Final Drainage Report The Rock Commerce Center

PCD File No. PPR2329

July 28, 2023
October 20, 2023
Project No. 23009.001

SHEET
DNG-1

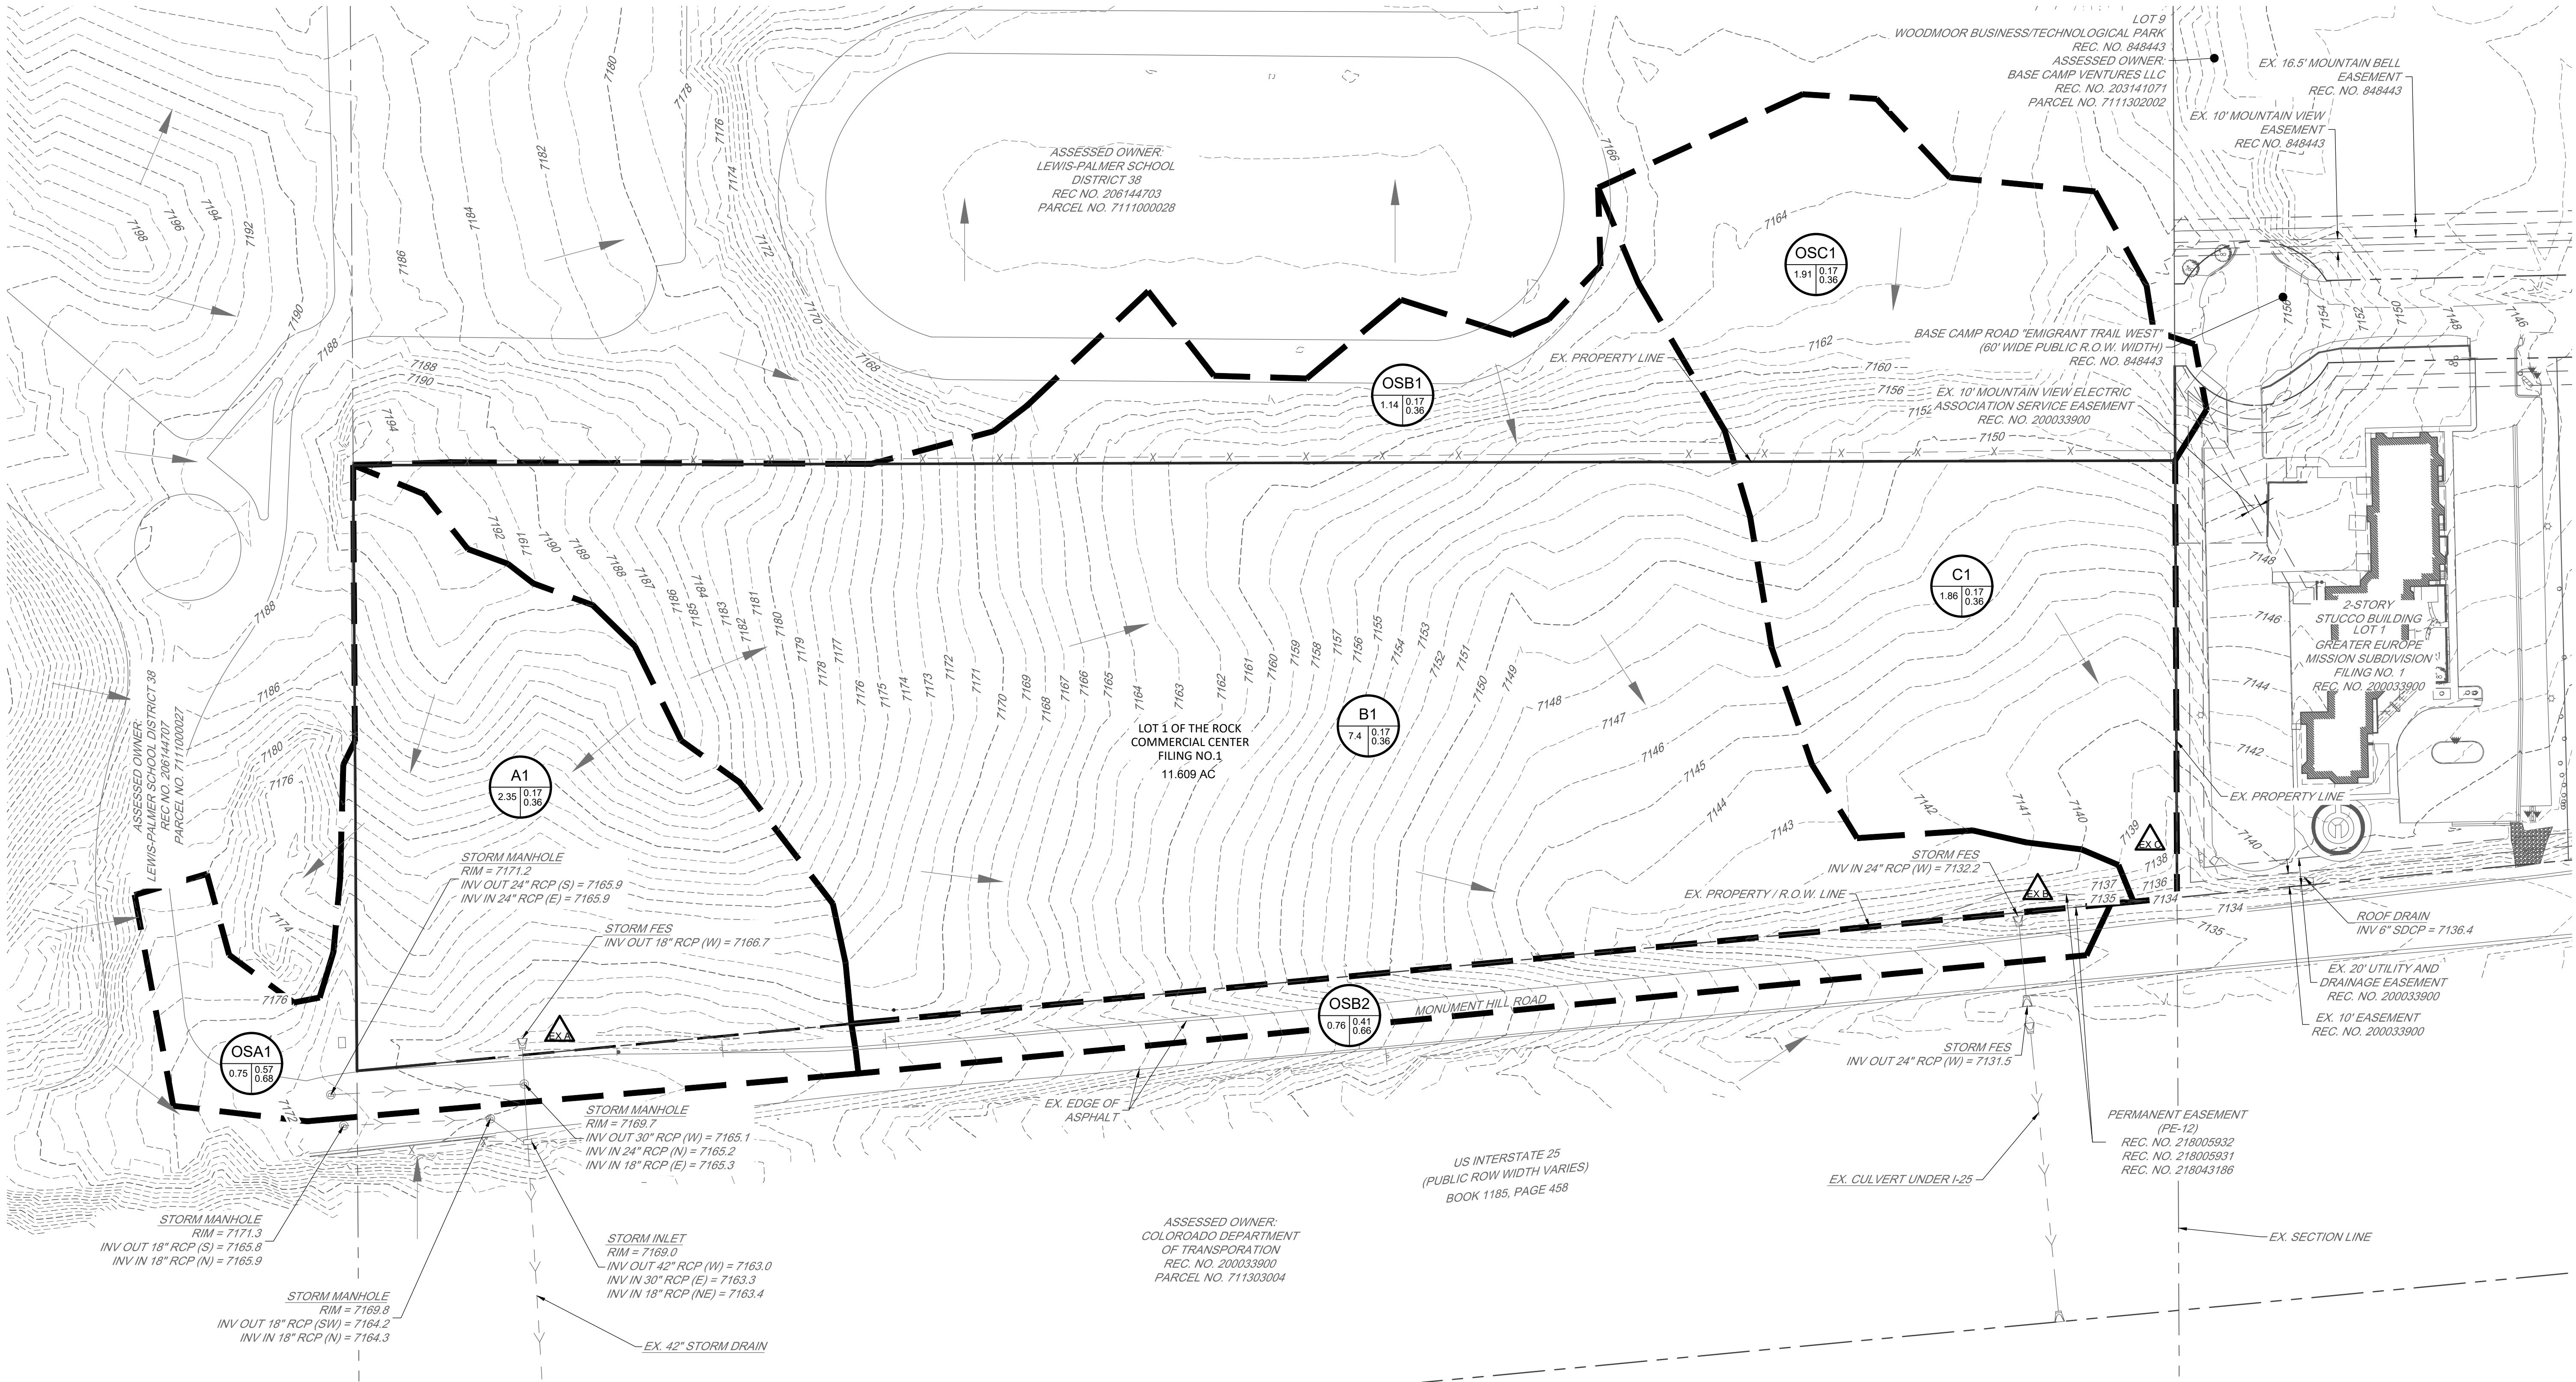
The design point flow summary states 3.07 & 7.27 cfs for the 10 & 100 year storms at Design Point A. Please revise statement if you are referring to basin flow only. Similar comment for other basins described in this section.
